Subject: OYSTER CREEK GENERATING STATION (OCGS)
DOCKET 50-219
SUPPLEMENT TO OCGS SEA TURTLE BIOLOGICAL ASSESSMENT

RESPONSES TO NMFS SEA TURTLE INFORMATION REQUESTS

Figure 5-5. Number of Kemp's Ridley Nests at Rancho Nuevo Before and After Implementation of TED Regulations in 1989 (After Marquez et al. 1999).

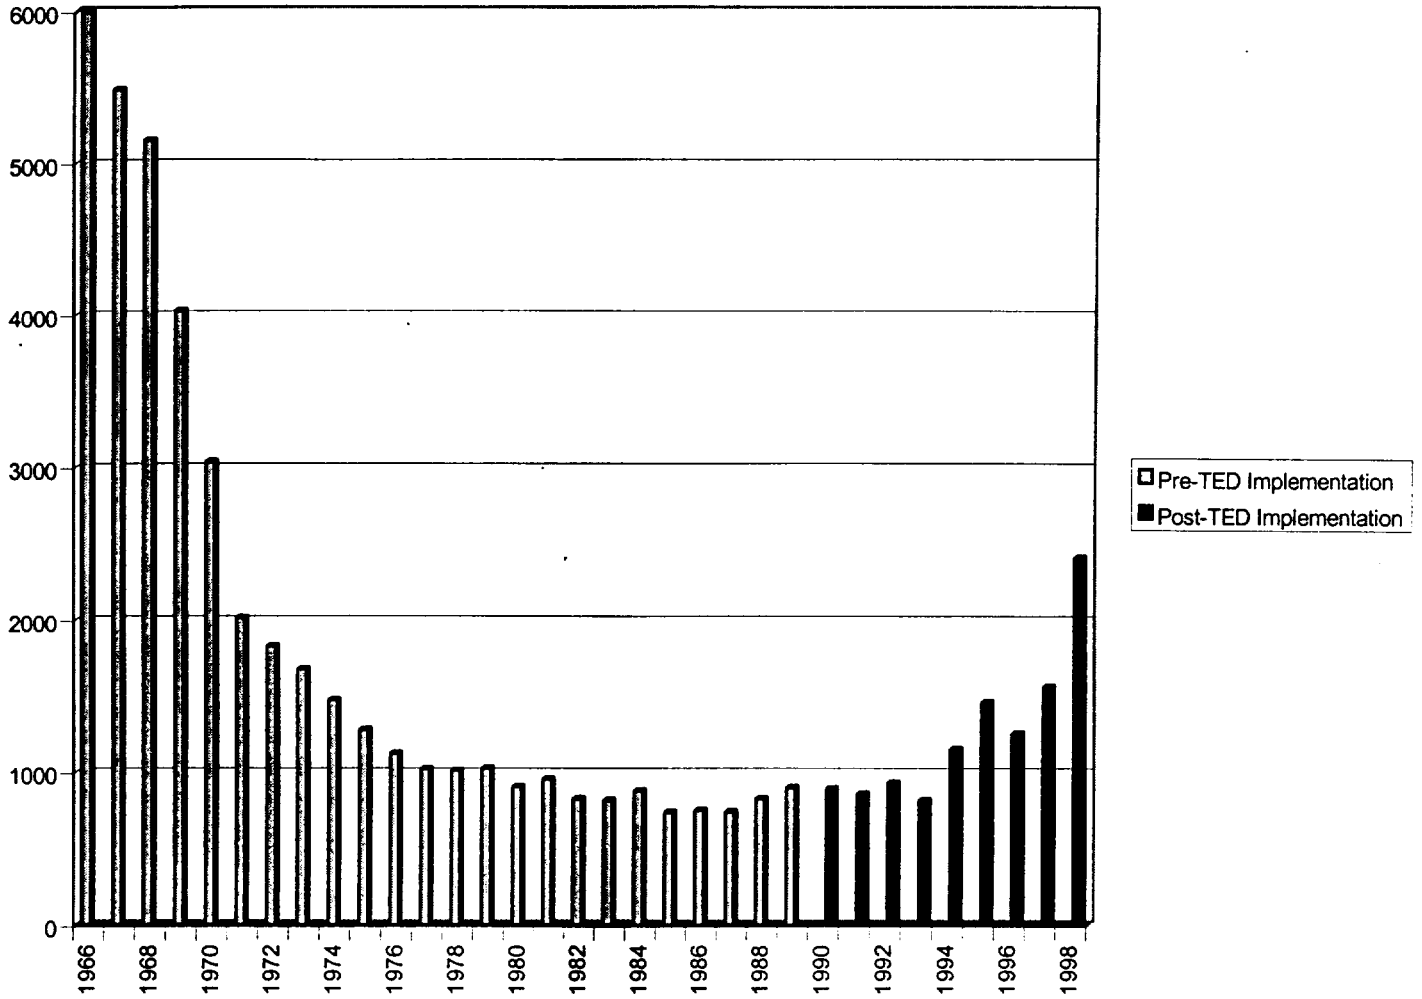
(5) Q. Update the sea turtle stranding data discussed in the BA. Specifically, data in Table 5-2 and Figure 5-5 only extend to 1994, while Figure 5-6 only presents data from 1977 to 1984. The New Jersey annual strandings in Table 5-1 range from 1977 to 2000, but are current stranding numbers available for the other figures and tables? If so, these data should be included in the BA.

An updated version of Figure 5-5 (enclosed) which illustrates the number of Kemp's ridley nests at Rancho Nuevo before and after implementation of TED regulations has been prepared based on data from Marquez et al., 1999. The recent data indicates that although the number of nests remained below 1000 during the entire decade of the 1980's, Kemp's ridley nesting at Rancho Nuevo has gradually increased during the 1990's subsequent to implementation of TED regulations and active conservation programs in the United States and Mexico. The number of nests has remained above 1000 since 1994 and reached a peak of 2409 nests in 1998.
